# Service Bulletin

Bulletin No.: PI1513F

**Subject:** Coolant Smell and/or Slight Leak at Radiator

**Models:** 2015-2016 Cadillac Escalade Models  
2014 Chevrolet Silverado 1500 (Plant Code G\*) (without RPO NHT - Max Towing Pkg)  
2014 Chevrolet Silverado 1500 (Plant Code F\*, Z\*)  
2015-2016 Chevrolet Silverado, Suburban, Tahoe  
2014 GMC Sierra (Plant Code G\*) (without RPO NHT - Max Towing Pkg)  
2014 GMC Sierra 1500 (Plant Code F\*, Z\*)  
2015-2016 GMC Sierra, Sierra Denali, Yukon Models, Yukon Denali Models  
Equipped with 4.3L, 5.3L or 6.2L Engine (RPOs LV1, LV3, L83 or L86)  
2016 models: SOP to 15 Nov 2015  
\*For Build Plant Information See 11th Position of VIN

4082322

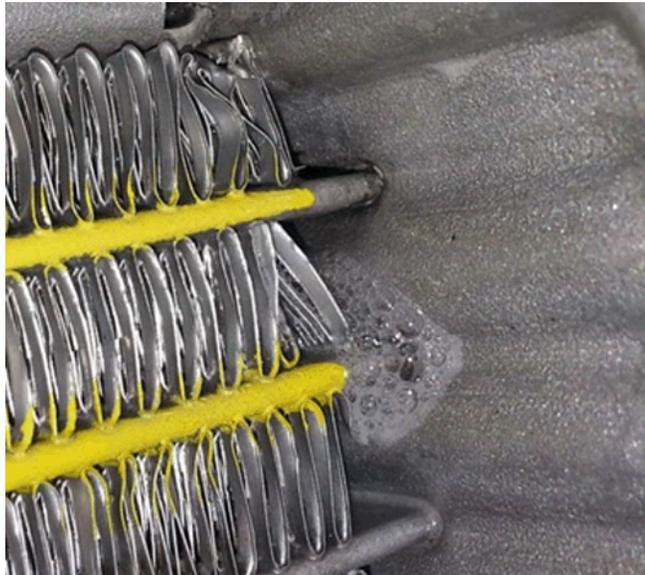
Technicians should start by inspecting the radiator for signs of leaks. Normally, signs of leaks can be found where the tubes attach to the headers.

This condition may be the result of excessive thermocycles within the cooling system caused by excessive cycling of the thermostat. These excessive thermocycles within the coolant system may cause the tubes to fatigue, crack and leak at the radiator headers. To correct this condition, a new thermostat has been designed that eliminates the thermostats excessive cycling.

If this condition is found, in addition to replacing the radiator, the engine coolant thermostat housing (w/thermostat) must also be replaced. Refer to *Engine Coolant Thermostat Housing Replacement* in SI, which is located in the Engine Heating and Cooling section.
